## Addendum 1

### Tender 1311: Victoria St Pathway Reconstruction. Concrete Curb&Gutter

CURB DETAIL  
SCALE: NTS

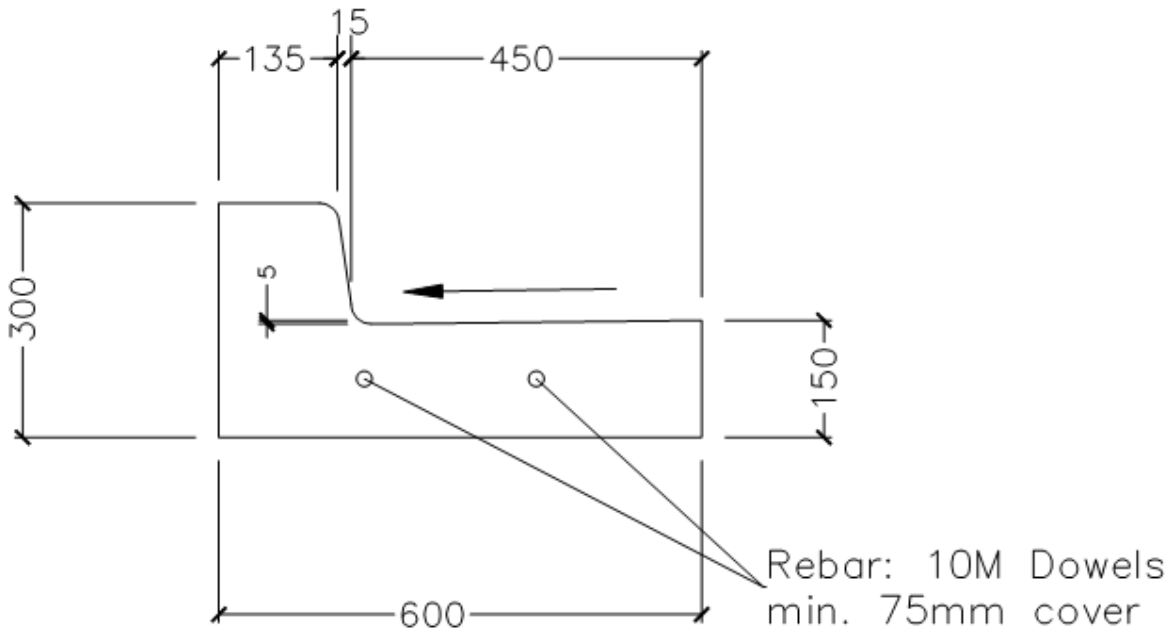
1. To Section 4, *Tender Price*:
  - *Item 2* is now only for hauling waste material to City Compost site (Willcocks Road) and paid based on truck volume. If you are directed by the Engineer to leave certain amount of material on site, you can dump it in the field at the east end of Victoria Street. Please exclude the cost of saw-cutting the existing highway pavement from the *Item 2* price. Include the price for saw-cutting in *Item 1*.
  - *Item 3 (new item)* is for the concrete ramp at the intersection of the pathway at 1st Street (2.4x2.0x0.75m). Cost includes shaping of existing, compacted base and installation of the concrete ramp on top of it.
2. Please notice that Curb&Gutter Detail has changed to City Standard (See Page 2). Also, note that distance between face of the gutter and your saw-cut is 450mm.
